DESIGN REVIEW/CERTIFICATE OF APPROPRIATENESS

Project/Property Address or Location: 6579 Taylor Rd.		Project Name/Business Name Taylor Commercial Park	
Parcel ID No.(s): 027-000008-00	Zoning Designation: OCT	Total Acreage: 23	
Please check all that apply:			
SITE PLAN ☒	LANDSCAPING ☒	BUILDING DESIGN ☒	DEMOLITION ☐ only applicable to Code Chapter 1150, Olde Gahanna
OTHER ☐			
Project Description: Two 31,050sf flex industrial buildings. Eight 7,750sf storage buildings. One 131,250 industrial building.			
APPLICANT Name -do not use a business name: Robert LeVeck		Applicant Address: 1500 W. Third Ave. Ste. 120 Columbus, OH 43212	
Applicant E-mail: rleveck@leveckconstruction.com		Applicant Phone No.: 614-582-4765	
BUSINESS Name (if applicable):			
ADDITIONAL CONTACTS Please List Primary Contact for Correspondence (please list all applicable contacts)			
Name(s):		Contact Information (phone no./email):	
PROPERTY OWNER Name: (if different from Applicant) Julie A. Faist		Property Owner Contact Information (phone no./email): 614-475-6677/julie.faist@gmail.com

FOR:
TAYLOR GATE BUSINESS PARK
TAYLOR GATE DR.
GAHANNA, OHIO 43230

Attn: Kelly Wicker, Administrative Assistant, kelly.wicker@gahan

A LANDSCAPE PLAN
SCALE: 1"=40'-0"

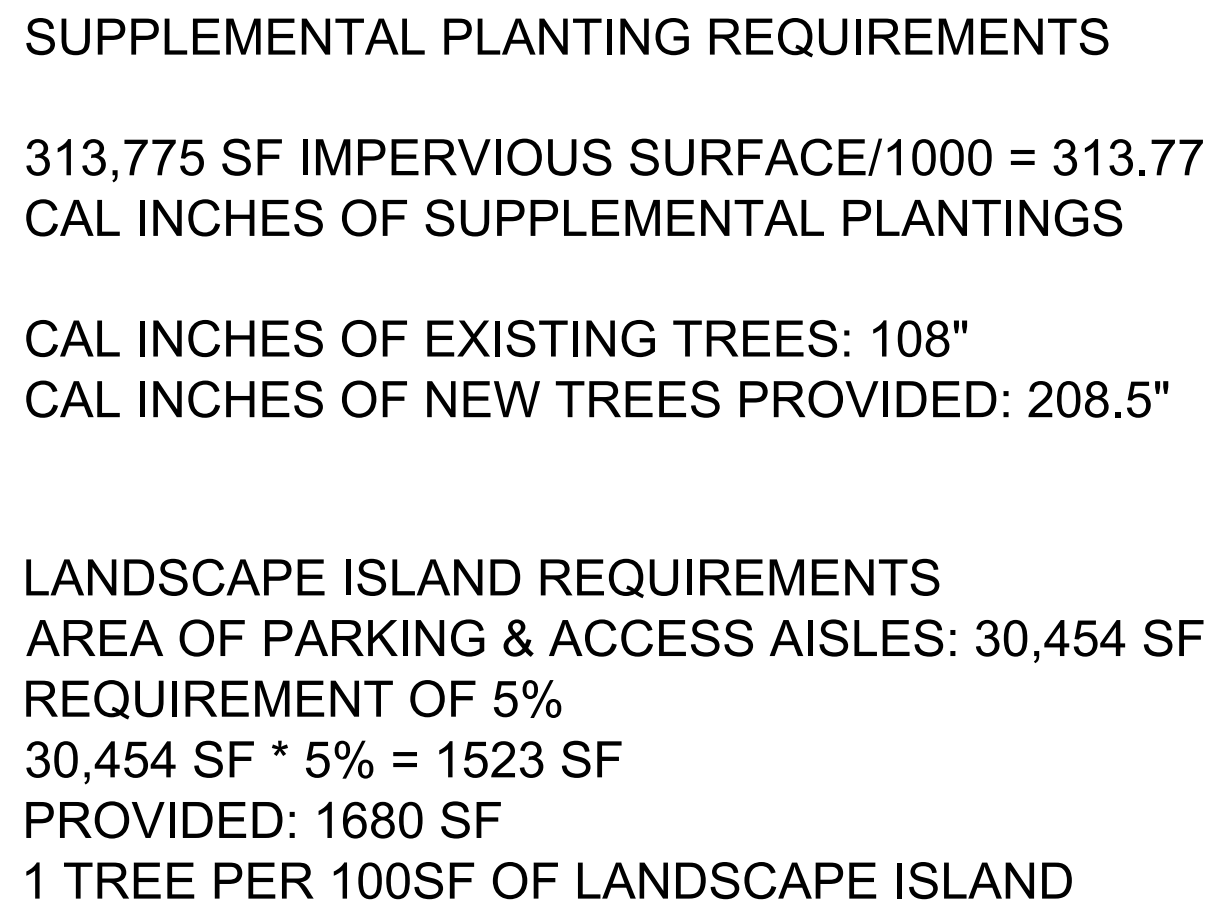
4. Landscape plan looks ok, but it is very heavy on red maples and maples in general. I would prefer to see some additional native tree genus and species.

7. A small portion of the loading area for Building I will be visible from Taylor Rd. Chapter 1155.06(g)(3) requires all loading areas to be screened from right-of-way by a minimum 6' high fence, wall, landscaping, etc. Please revise the plans accordingly or request a variance.

11. Fence details have been submitted but it does not appear that fencing location is shown the site plan. Please revise as necessary to clearly depict fencing location.

This design followed comments received in a prior site development review and the species used were similar to those required by that site review. In response to the comment, we have switched out the Red Maple with Honey Locust.

A section of fence is not provided (Landscape Plan) between Building A & B to screen the view.

Fence location shown on Landscape Plan.

BUILDING K ELEVATIONS

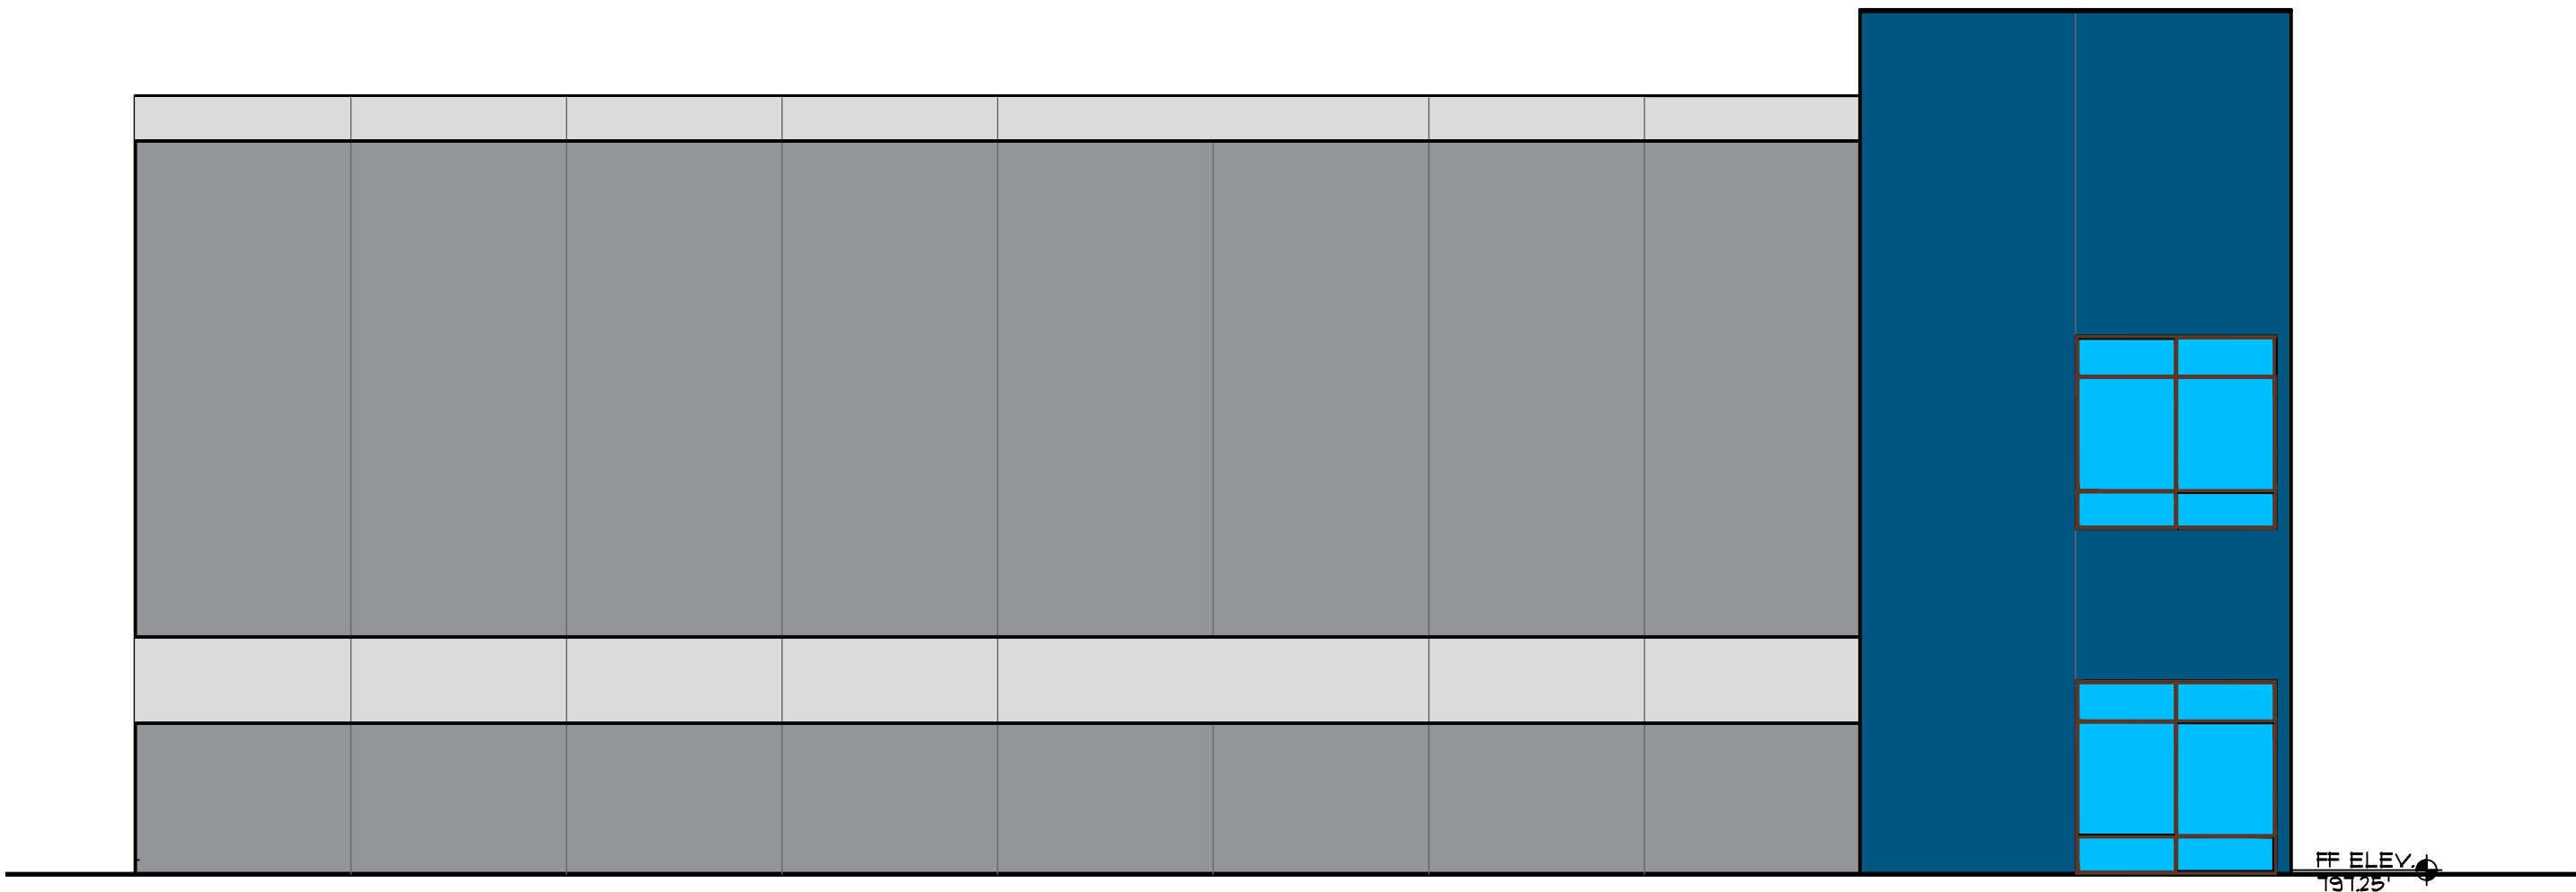
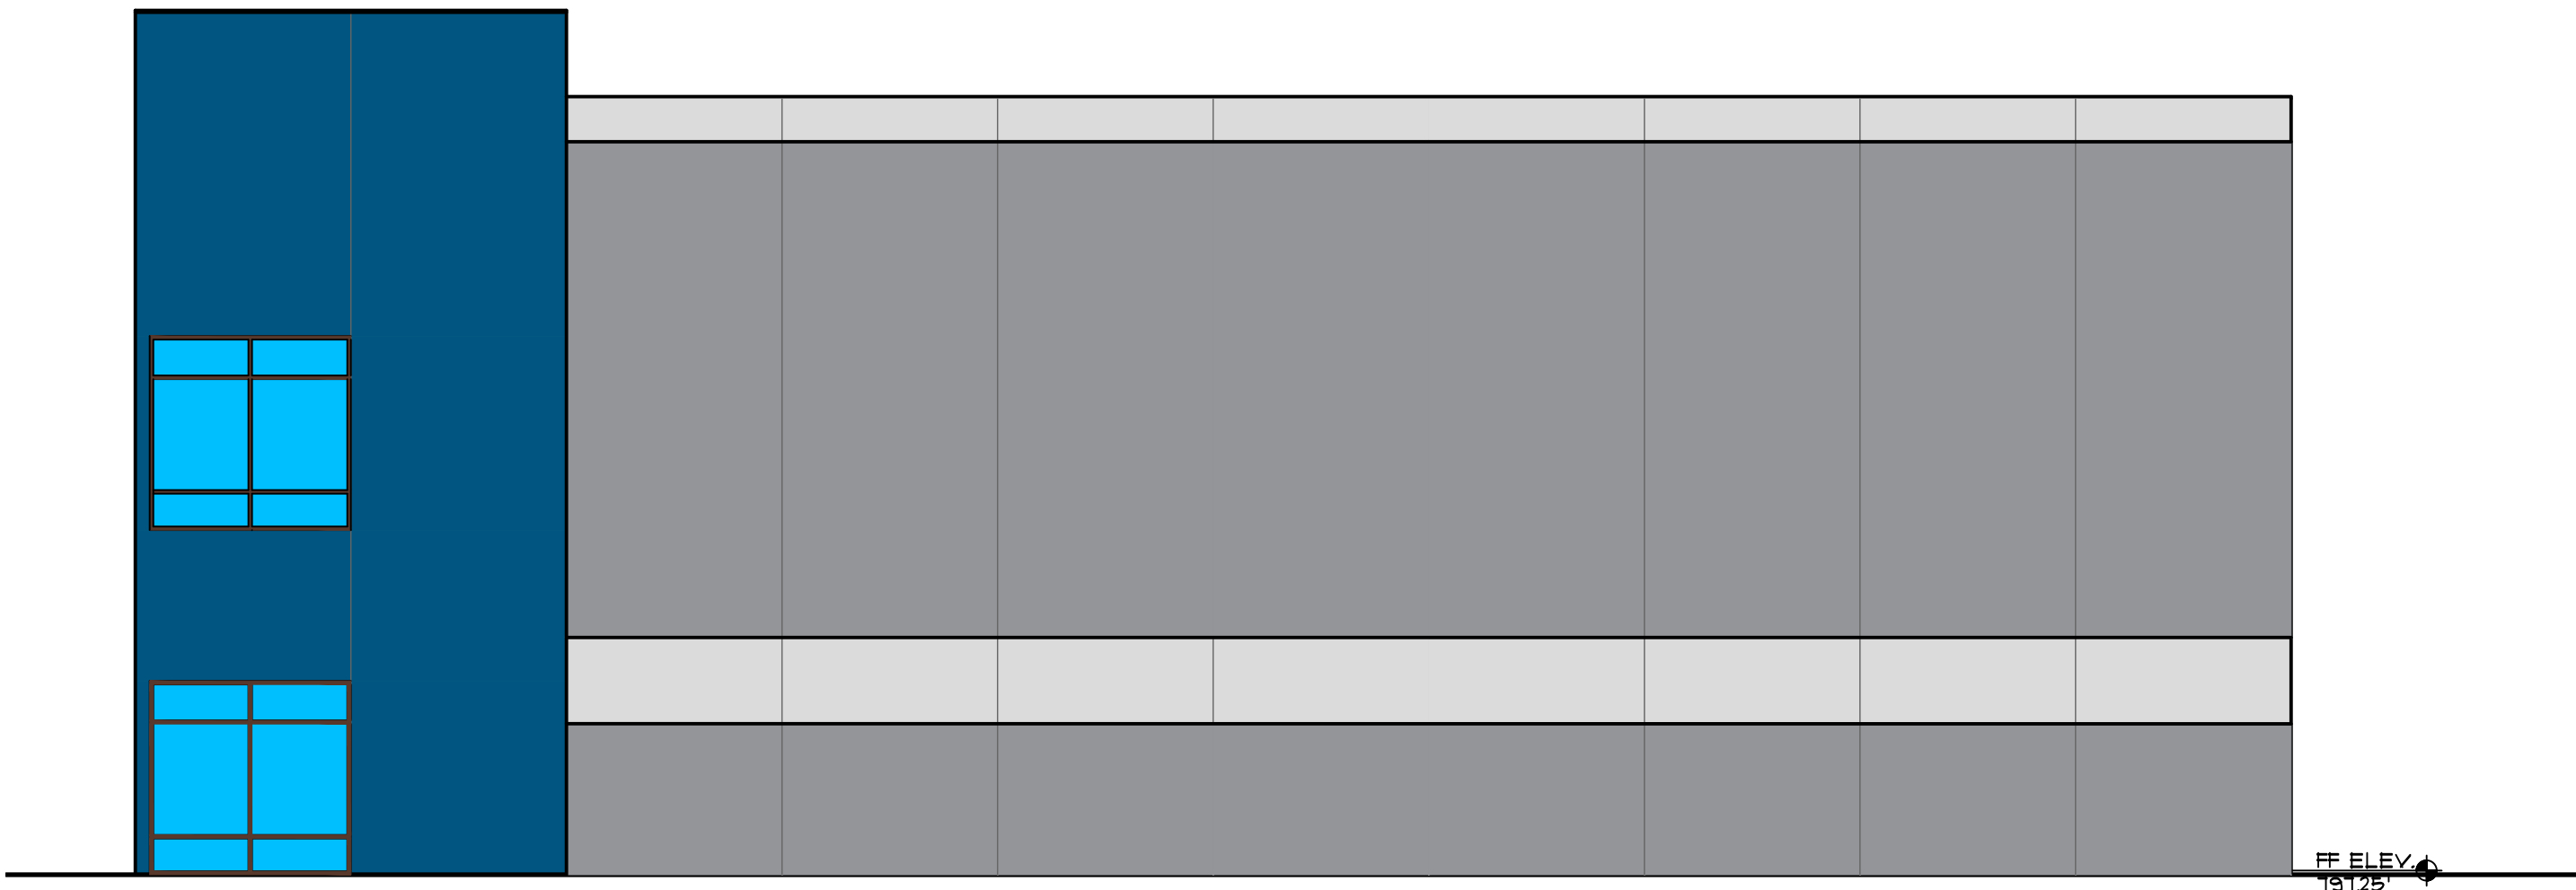
8. The east elevation for Building K is labeled as Building J. Please revise accordingly.

9. It appears what is labeled as the east elevation for Building K is actually the west elevation and vice versa. Please revise if necessary.

Drawing Corrected.

Drawing Corrected.
